# **SAUGEEN VALLEY CONSERVATION AUTHORITY**

## **ADMINISTRATIVE REVIEW**

File: Cedar Crescent Village

RE: Administrative Review – Application to Alter a Regulated Area

Figure 1  
Port Elgin Development  
Site Plan

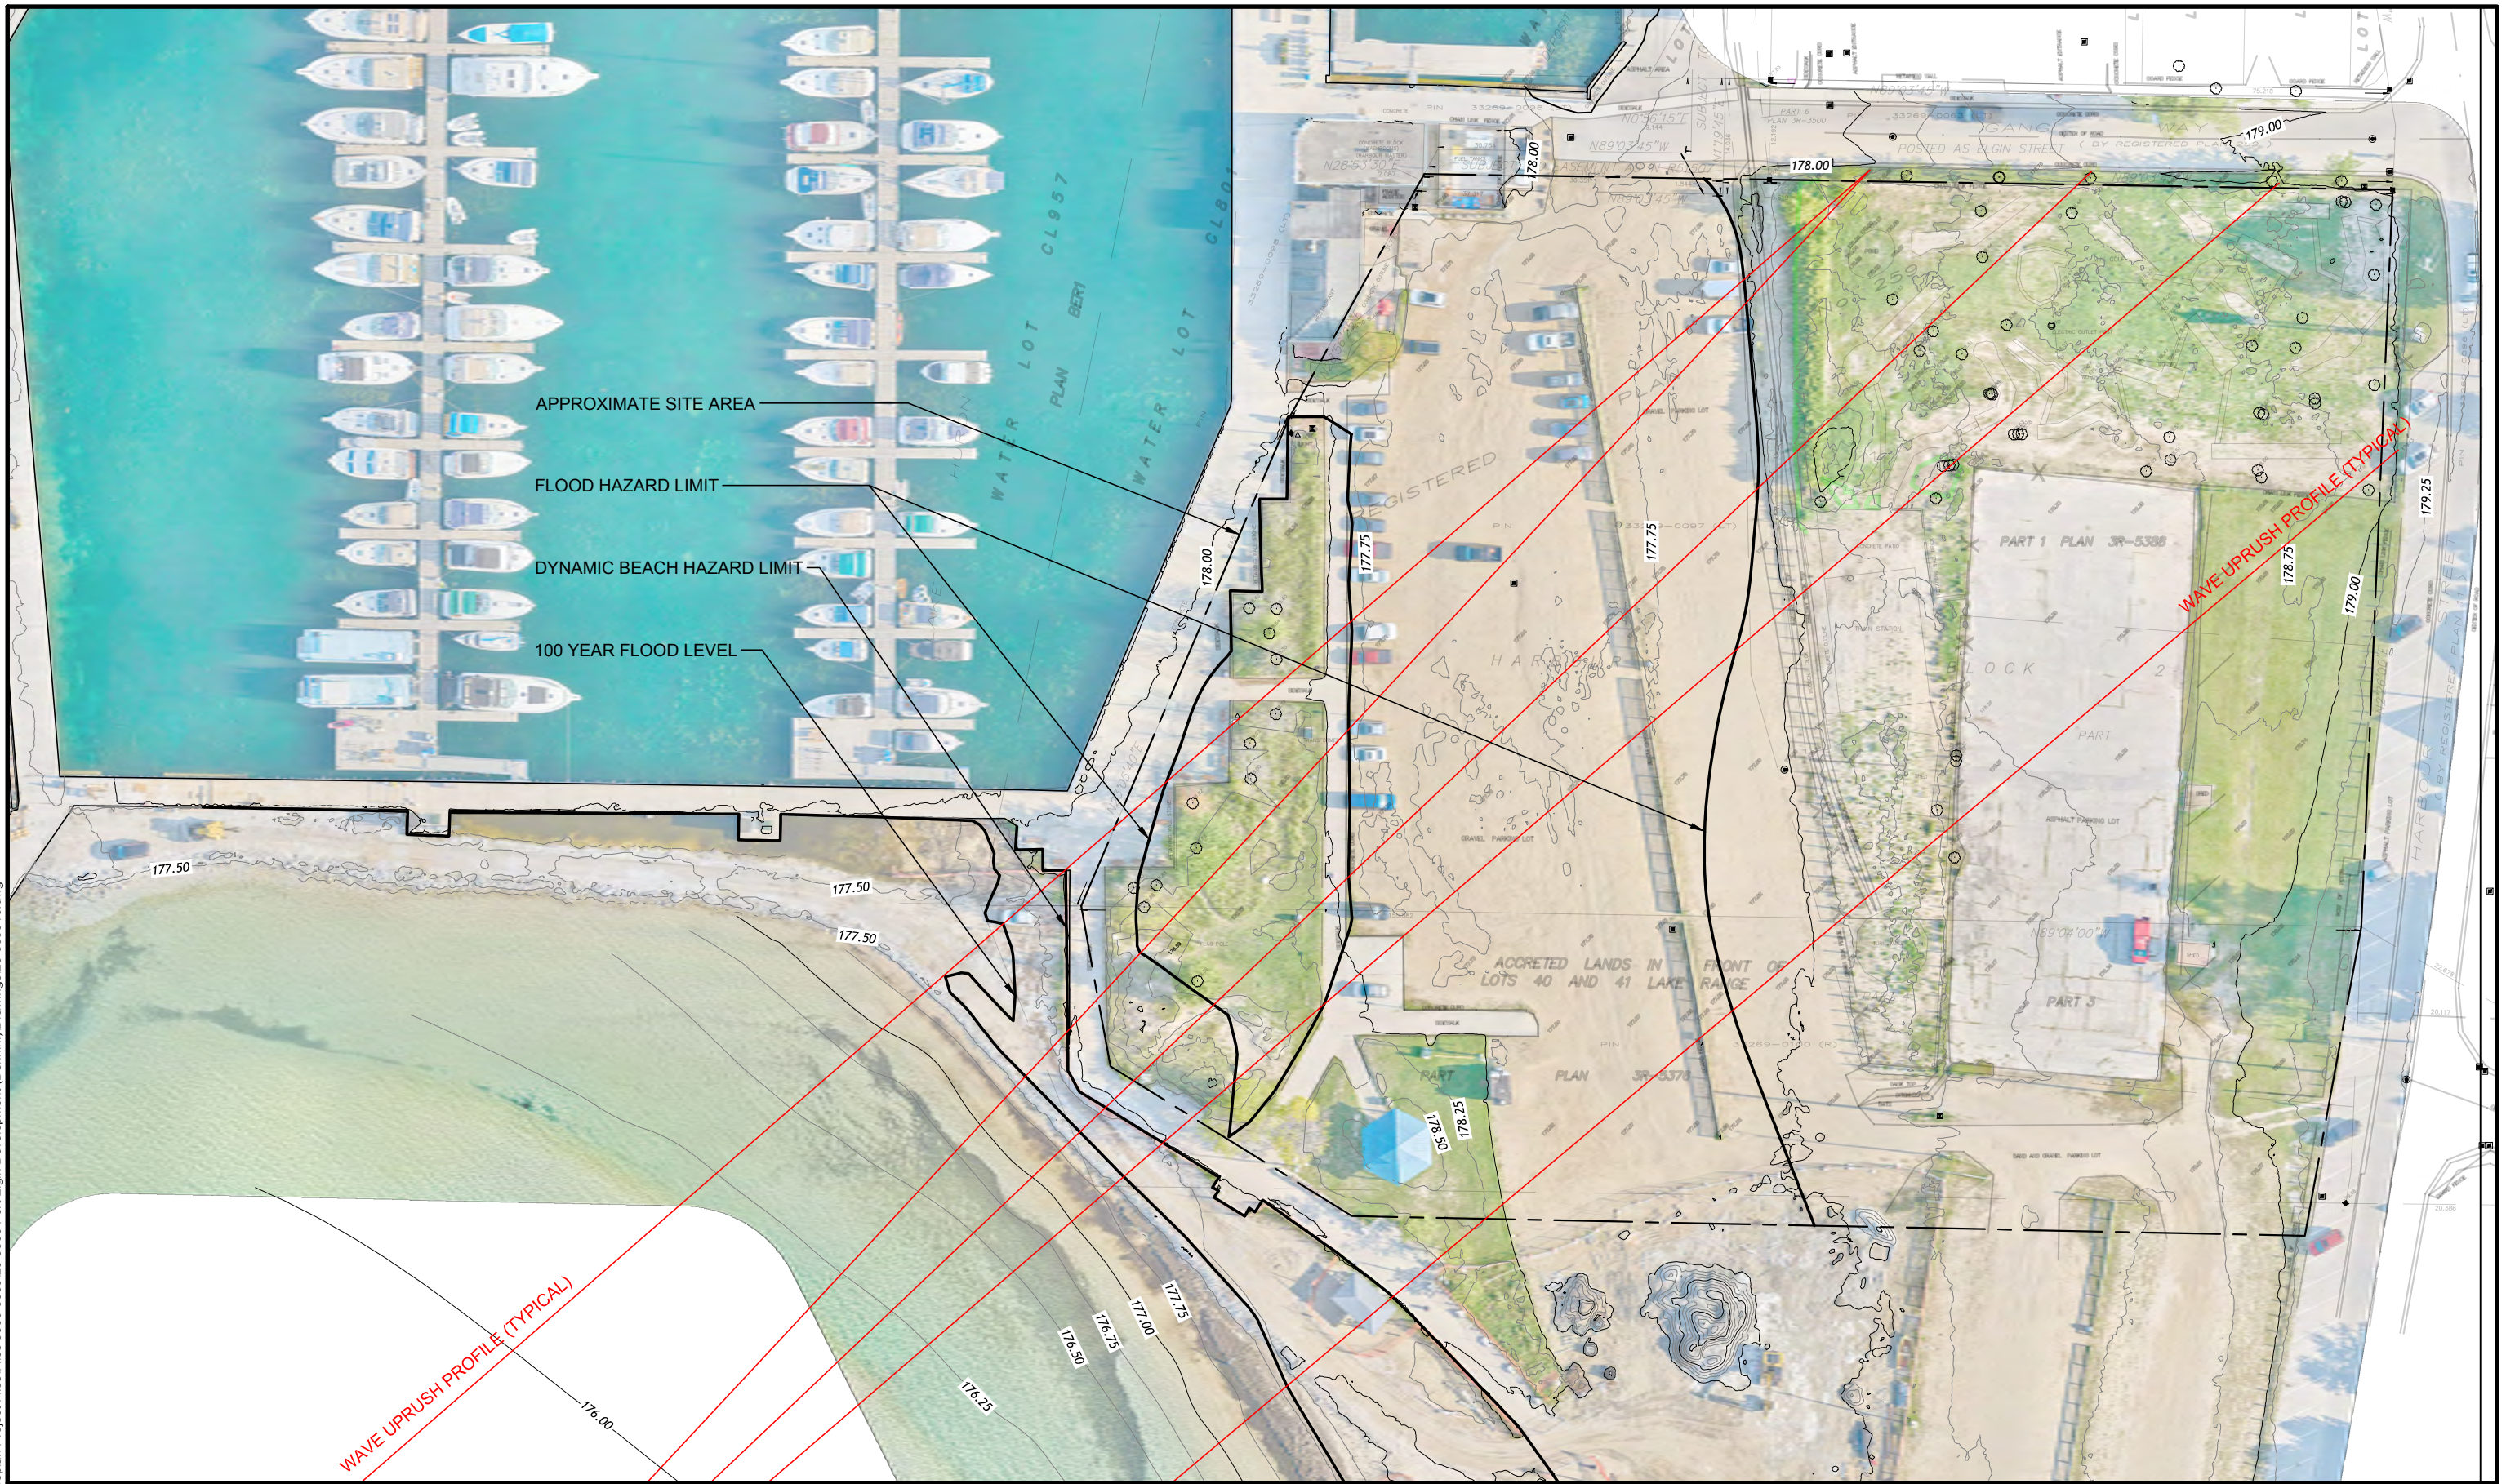
The suggested location of the 100-year flood level was noted on Figure 1 of the Shoreplan report, which includes the UAV collected aerial photograph as a background image. The position of this contour appears to be biased by the presence of the temporary construction road and rip rap placed to repair the marina breakwater. As seen in Photo 3 of the Shoreplan report, this area now features a sloping beach. Therefore, it does not appear this topographic data properly characterizes the current conditions of the beach to map the location of the 100-year flood level in MNR (1989) or an updated 100-year flood level based on the additional measured water level data from 1989 to 2020.

A line for the flood hazard limit is plotted on Figure 1 of the Shoreplan report. The elevation of the line is not noted on the figure but based on its location between the 177.5 m and 178.0 m contours, it would appear to be the lower of 100-year flood levels noted above (177.85 m not 178.65 m). Based on the contours in Figure 1, if 178.65 m was mapped as the flood hazard level, it would be located further inland near the eastern limit of the site, close to Harbour Street.

- If the 100-year flood level increases at Port Elgin/Southampton, then the runup analysis will have to be repeated.
- In Figure 1 of the original SEL report (Oct. 28, 2020) the runup profiles were mapped. There is no analysis of wave runup potential for the lowest section of the walkway (identified as the beach maintenance access point by Ms. Van Myall on the April 29, 2021 conference call between SVCA and TSS staff).
- This vulnerable section of the walkway needs to be evaluated for wave uprush to map the flood risk for the existing site conditions. The results should be presented in 2D for the beach and the parking lot at Port Elgin with either AutoCAD or GIS for the maximum potential uprush limit, not the lowest uprush elevation.

Figure 1 of our October 28, 2020 hazard assessment report showed the location of five of the seven uprush profiles considered in our original assessment. Two profiles were not shown because they were outside the site limits considered in that report.

Figure 9 shows the locations of the ten profile lines and the calculated flood hazard limit. The flood hazard limit is based on the calculated extent of wave incursion onto the subject property. It is not based on any specific elevation.

Figure 5 Example Wave Uprush Analysis Results

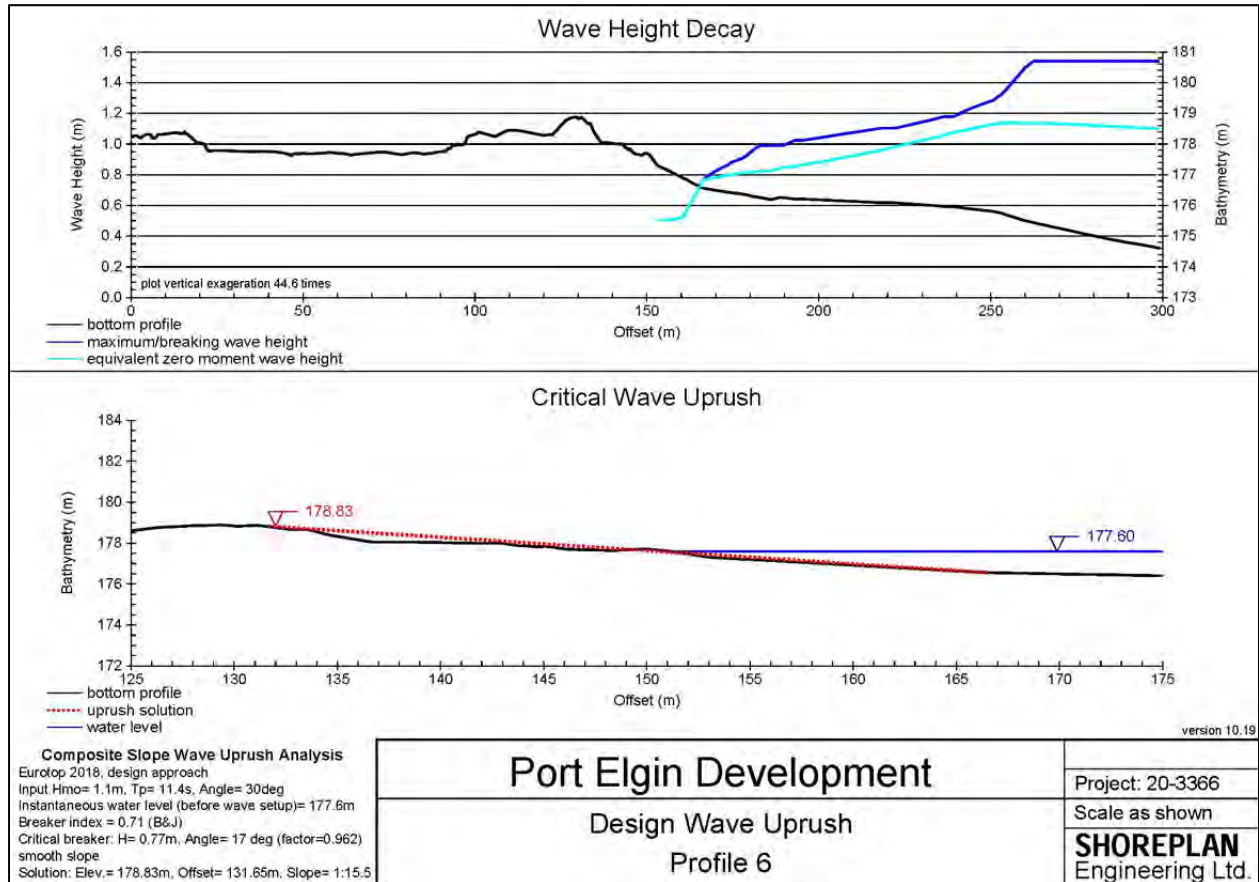
Finally, the sample wave runup calculation presented in Figure 5 of the report indicates a value of 1.23 m or an elevation of +178.83 at Profile 6, which is higher than either of the conflicting results presented in the body of the report (although it is unclear for what input conditions these results were obtained). The establishment of the appropriate wave runup elevation is not well documented. Based on our experience, for a narrow, gently sloping sandy beach with 20-year offshore wave heights exceeding 7 m, a wave uprush height of only 25 cm would appear to underestimate wave runup potential.

We do not discuss any other flood hazard uprush elevations in our October 2020 report. Uprush associated with floodproofing is a separate item and the distinction between a flood hazard assessment and a floodproofing assessment is important. Figure 5 in our report has a plot showing an uprush elevation of 178.83m on the constructed dune south of the marina, but that figure was included as an example only. That uprush elevation did not cause the governing flood hazard limit so it was not discussed, but its impact can be seen in Figure 1 from our report. A portion of the constructed dunes adjacent to the marina are not within the flood hazard because, as shown in report Figure 5, the uprush does not extend all the way up the dunes.

Figure 1 Draft Master Plan

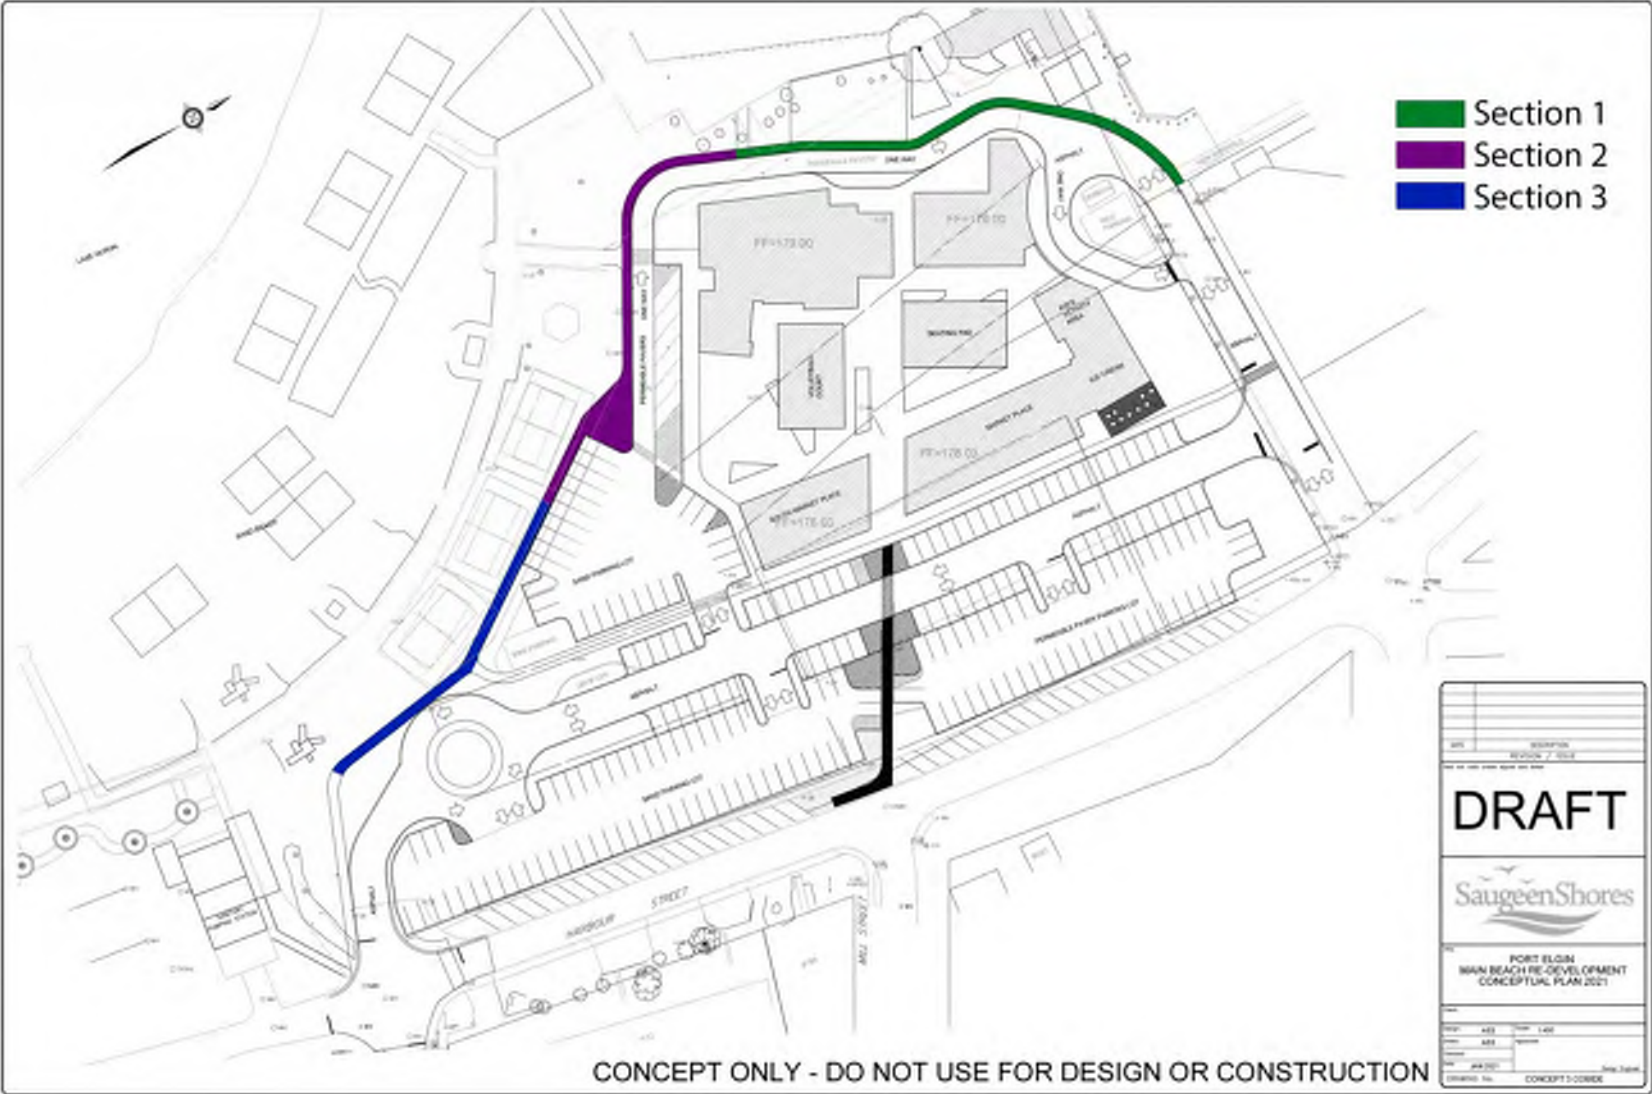
Figure 1 below shows a draft Mater Plan concept for the Cedar Crescent Village site and the Town owned lands to the south. We have coloured three sections of a sidewalk that follows the perimeter of the plan. The portion identified as Section 2 fronts the path of the greatest exposure of the building locations to wave uprush. If Section 2 of the sidewalk is constructed at elevation 178.5m GSC, wave uprush will just reach the edge of the sidewalk in front of the proposed buildings under floodproofing design conditions. This was calculated using the uprush procedure described in our October 2020 report and assumed a rise in grade from the landward side of the existing paving stone walkway to the new sidewalk. There would be an approximately 0.5m rise in grade over a width varying between approximately 14 and 22m. That is a gentle enough slope that the fill could be stabilized with suitable vegetation, including dune grasses if so desired. This could also be an opportunity to re-establish portions of the dunes that were once part of this site.

The elevation of Sections 1 and 3 shown on Figure 1 may vary as required to produce a workable grading plan for the entire site. We recommend that Section 1 be at elevation 178.0m or higher to prevent any water that overtops the marina wall from flooding into the development site.

Figure 9 Updated Flood Hazard Limit

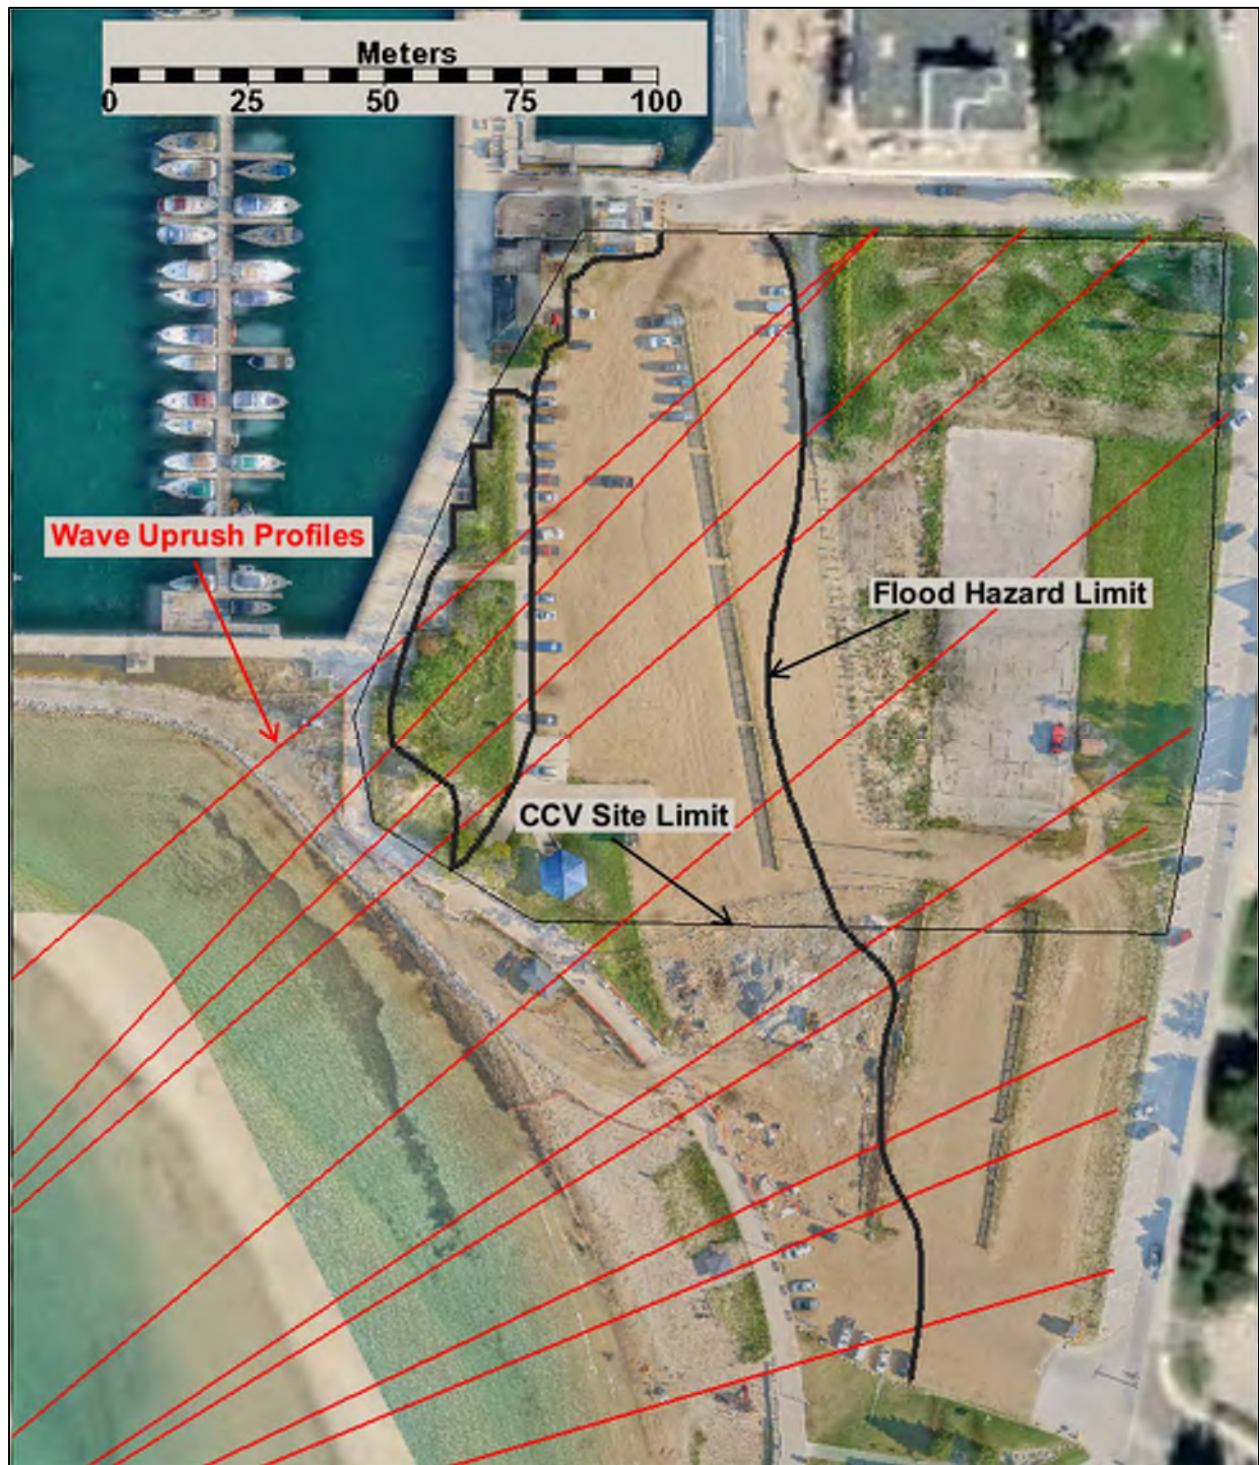
- If the 100-year flood level increases at Port Elgin/Southampton, then the runup analysis will have to be repeated.
- In Figure 1 of the original SEL report (Oct. 28, 2020) the runup profiles were mapped. There is no analysis of wave runup potential for the lowest section of the walkway (identified as the beach maintenance access point by Ms. Van Myall on the April 29, 2021 conference call between SVCA and TSS staff).
- This vulnerable section of the walkway needs to be evaluated for wave uprush to map the flood risk for the existing site conditions. The results should be presented in 2D for the beach and the parking lot at Port Elgin with either AutoCAD or GIS for the maximum potential uprush limit, not the lowest uprush elevation.
